1. **ORIGIN:** Development Assessment Unit

FILE REF: DA3340/325 Pt2

Proposed Mixed Use Development at Lot B DP 102496, Lot B DP 372324, Lot 3 DP 825580 & Lots 4 & 5 DP 24376 No. 78-80 Marine Parade, Kingscliff

SITE DIAGRAM

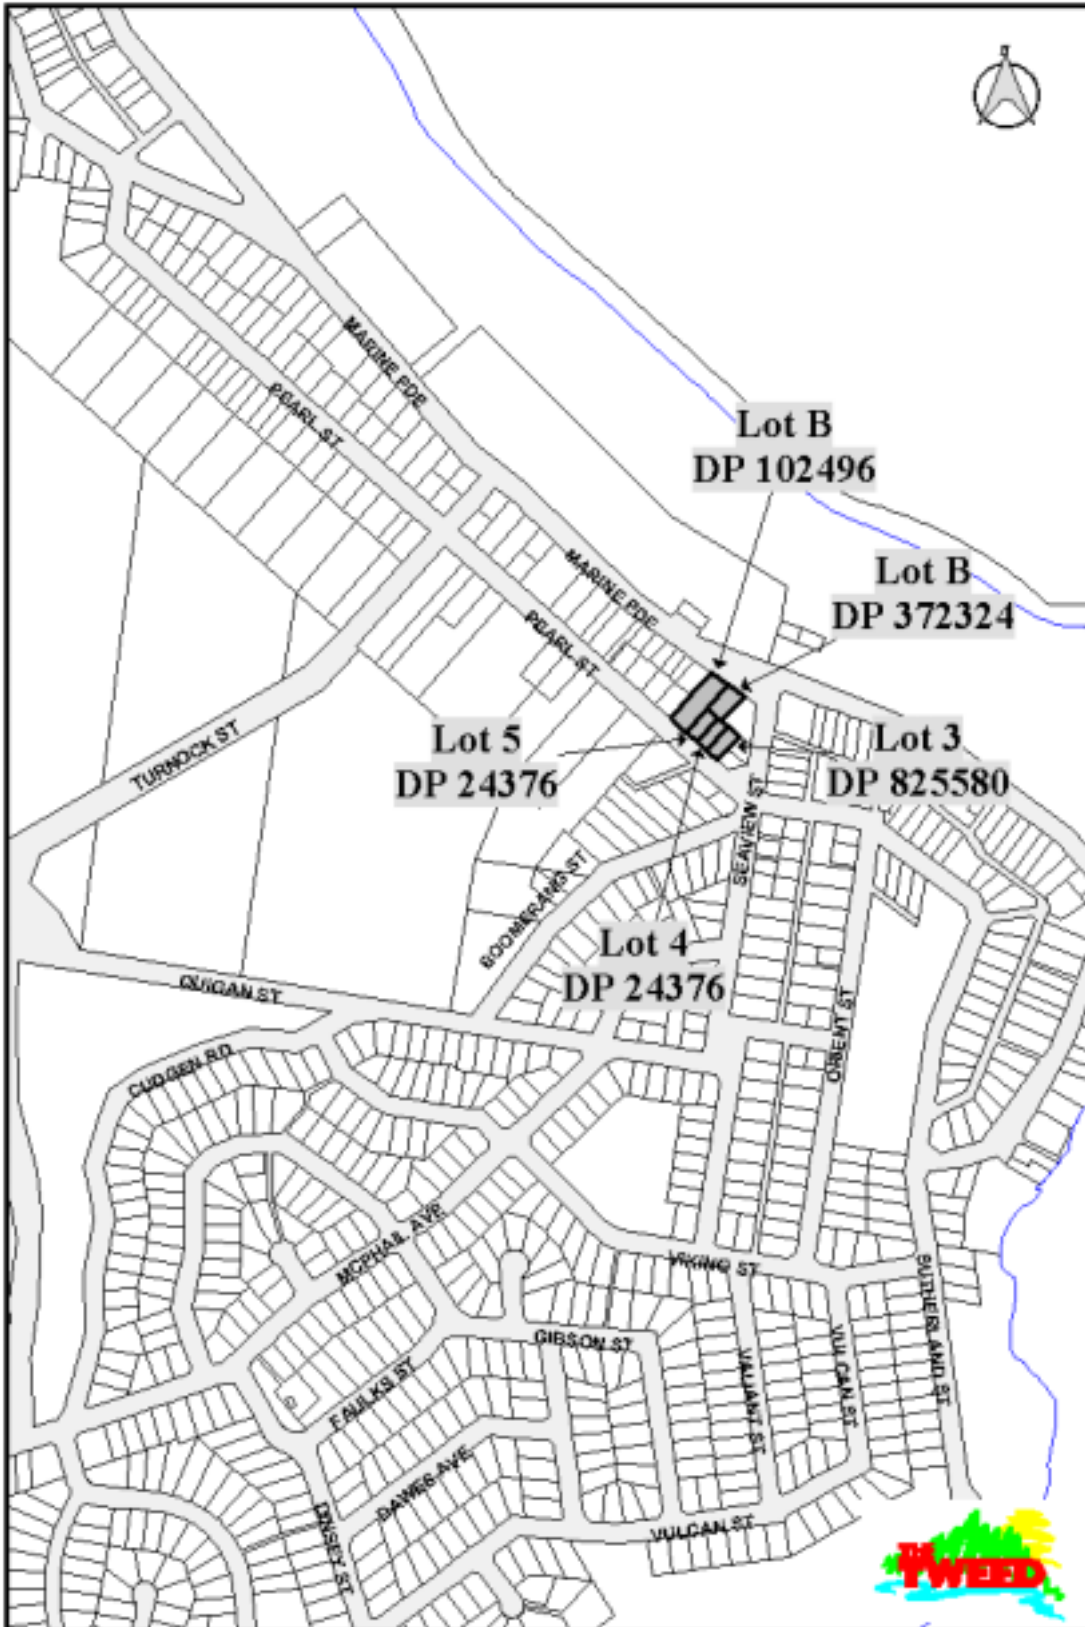
Council officers have also raised concern in relation to the legal right of the applicant to utilise and carry out works over the existing easement through Lot 1 DP 825580 to Seaview Street. In response to Council’s concerns, the applicant’s solicitor has provided the following information:-

Accordingly, the applicant has since advised Council that the proposed pedestrian accessway will be paved only, with no provision for either fencing, lighting or landscaping. As stated previously, the owner of the affected property has also provided a submission from their solicitors, which states that the existing instrument does not confer a legal right to utilise for the purposes proposed. Accordingly, and having regard to the insufficient time permitted to further consult with the affected owner, the applicant and possibly even Council's solicitors, the proposed pedestrian access to Seaview Street should not at this stage be supported.
